## **II. Responses to Comments**

### B. Matrix of Comments Received on the Draft EIR

### **C. Comment Letters**

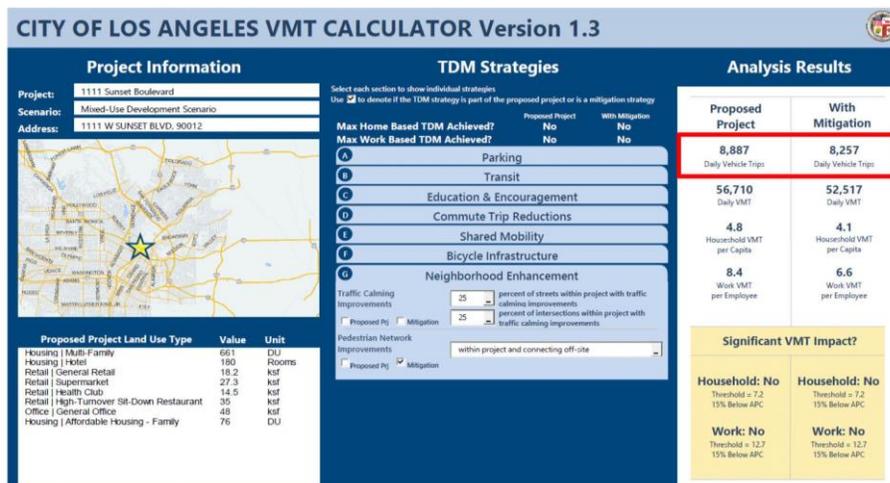
suggested in this comment to assume that the entire CalEEMod regional default value of 20 miles per haul trip be used to evaluate impacts from the portion of the trip exclusively on the Project Site.

The purpose of the Construction On-site scenario was to address potential localized impacts from on-site construction emissions. As shown in Table IV.A-8 of the Draft EIR, localized impacts at nearby off-site sensitive receptors were concluded to be less than significant.

This comment correctly identifies that the haul trip length was increased from the default value of 20 miles to 25 miles to account for soil export to Irwindale. Likewise, the vendor trip length for concrete trip was reduced from the default trip length of 6.9 miles to 6.5 miles since concrete would be delivered from the Catalina Pacific facility. No changes to the default trip lengths for employees and other vendor trip were used in the analyses. As discussed in Response to Comment No. 5-41, the Project is not representative of the CalEEMod default project scenario and instead the analysis reflects project-specific assumptions. Thus, the number of trips for employees, vendor trips, and haul trips (e.g., based on the amount of soil export) are all based on the construction requirements for the Project. SWAPE has not provided any evidence as to why the construction assumptions used in the Draft EIR analysis would not be representative of the Project’s construction.

**No Hotel Development Scenario:**

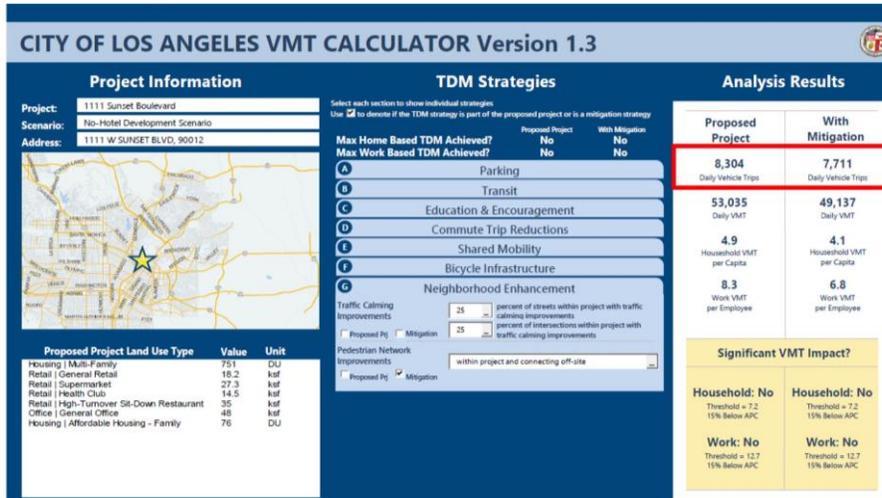
Furthermore, the No Hotel Development Scenario is expected to generate approximately 8,257- and 7,711-daily vehicle trips without and with mitigation, respectively (see excerpt below) (Appendix C, pp. 180).
